Re Conversion of Outbuilding to Accommodation Cliff Farm Iburmdale  
Whitby

**AMENDED**

**PROPOSED CONVERSION OF  
OUTBUILDING TO ACCOMMODATION  
AT CLIFF HOUSE FARM  
IBURDALE**

PROPOSED

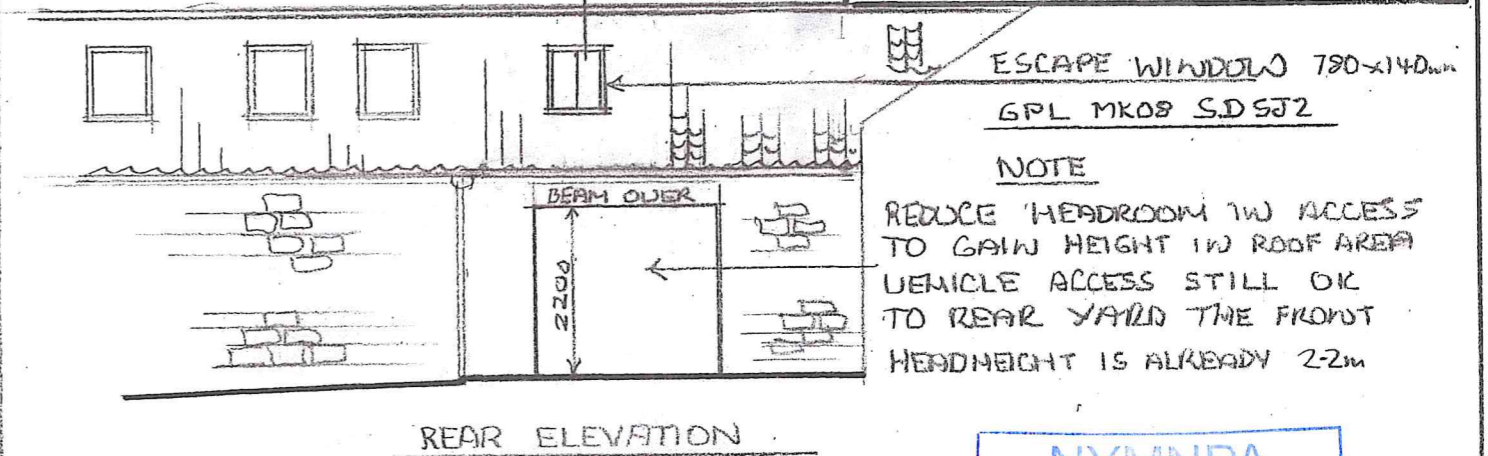
NOTE  
EXCEPT FOR VELUX WINDOW  
THE EXISTING FRONT ELEVATION  
IS THE SAME

VELUX WINDOWS

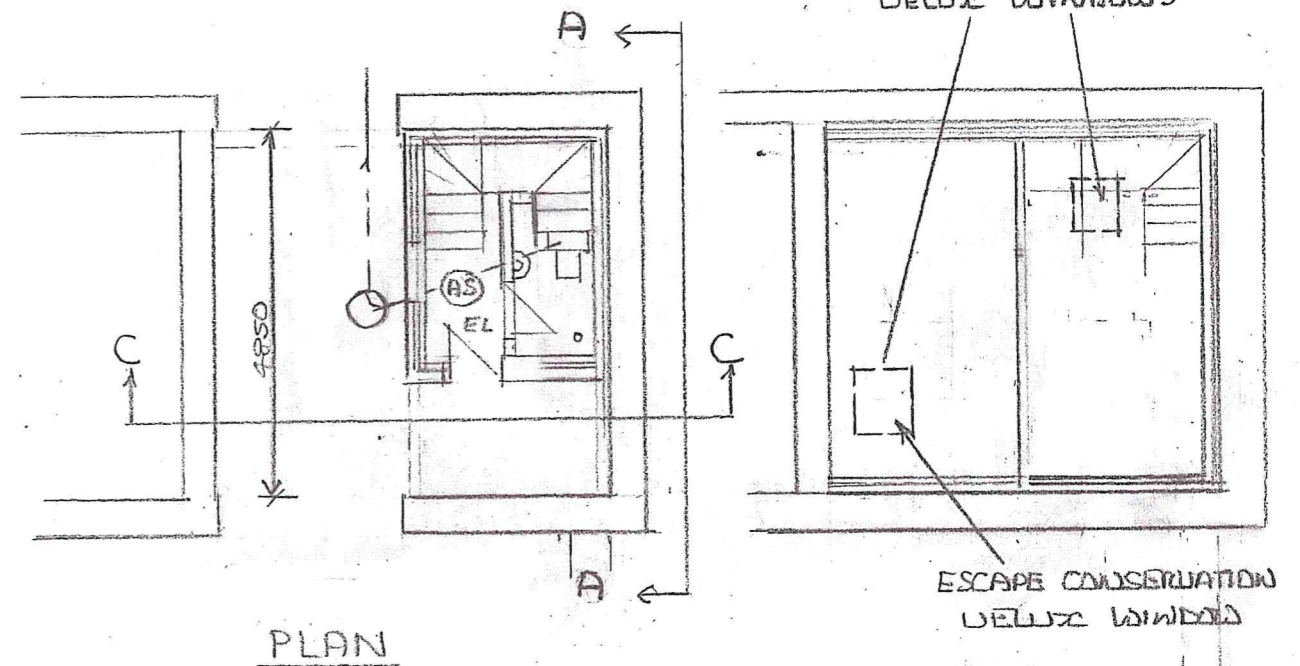
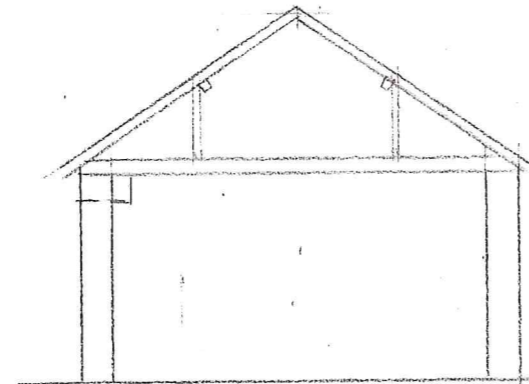
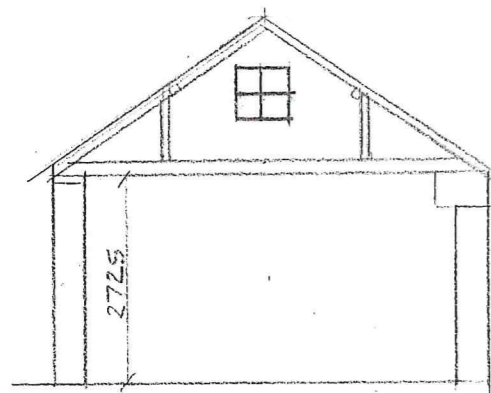
REMOVE DORMER WINDOW  
AND REPLACE WITH  
CONSERVATION VELUX WINDOWS

Dormer removed from  
Scheme + rooflight  
added.
